Service Letter**PRODUCT SUPPORT PROGRAM FOR REPLACING THE CHECK VALVE AND REGULATOR ON CERTAIN C13 ON-HIGHWAY ENGINES**

Media Number -REBE9063-00

U-549
TT-4***Before/After*****PRODUCT SUPPORT PROGRAM FOR REPLACING THE CHECK VALVE AND REGULATOR ON CERTAIN C13 ON-HIGHWAY ENGINES****1274****PS43726****NOTE:**

Image1.1.1

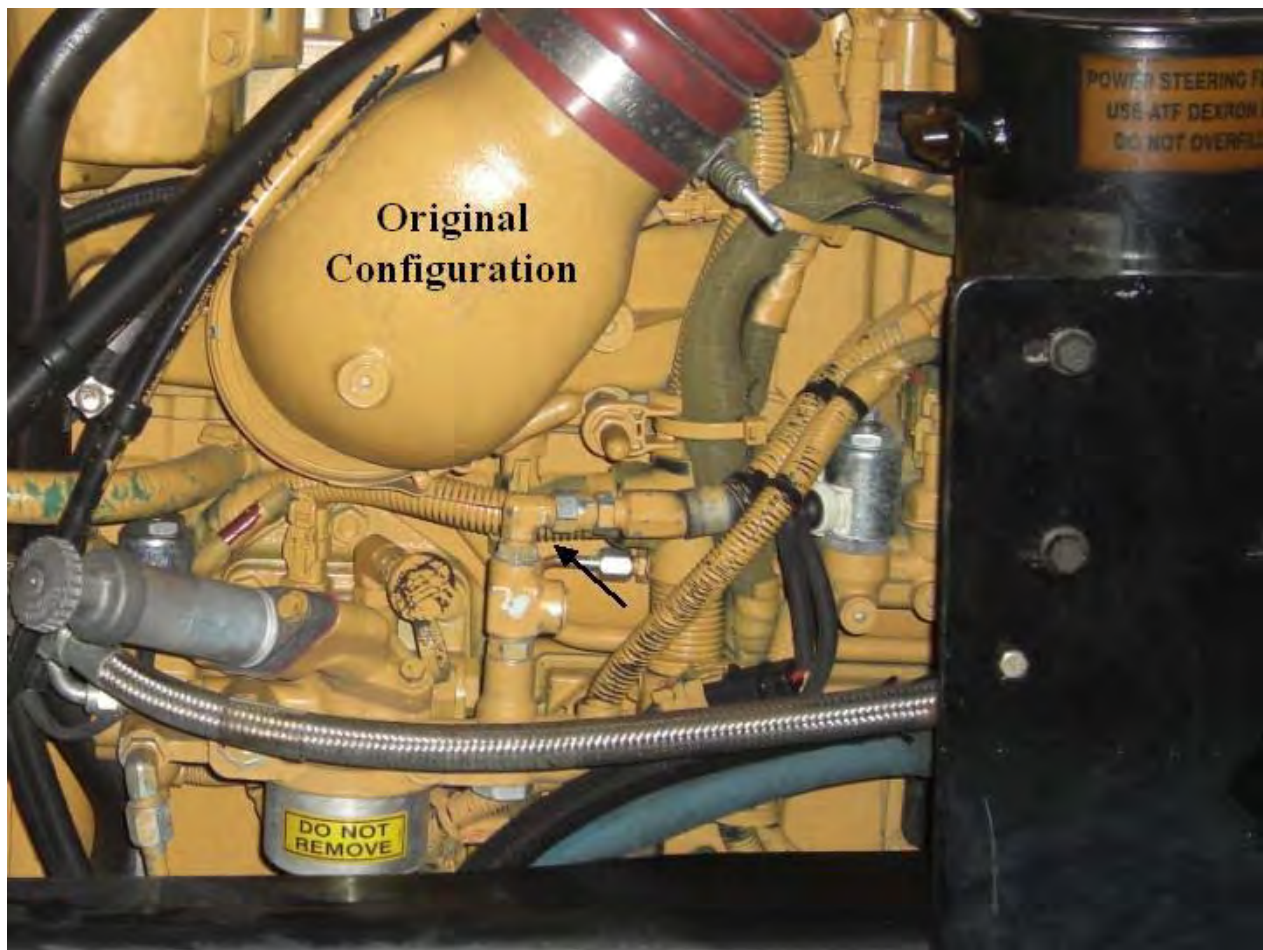
1. Remove the 030-7947 elbow from the 304-8022 tee. The elbow will not be reused. Image1.1.1 Original Tee Fitting
2. Remove the 001-6286 Straight Fitting from the end of the 308-6339 Hose and replace the 001-6286 Straight Fitting with the 068-0009 90 Degree Fitting.
3. Install the 327-0377 Check Valve into the top of the 304-8022 Tee.
4. Connect the 068-0009 90 Degree Fitting to the 327-0377 Check Valve. Image1.1.2 New Configuration
5. Remove the 233-6742 Check Valve from the bottom of the filter base and replace with the 3274448 Valve. Image1.1.3 Filter Base
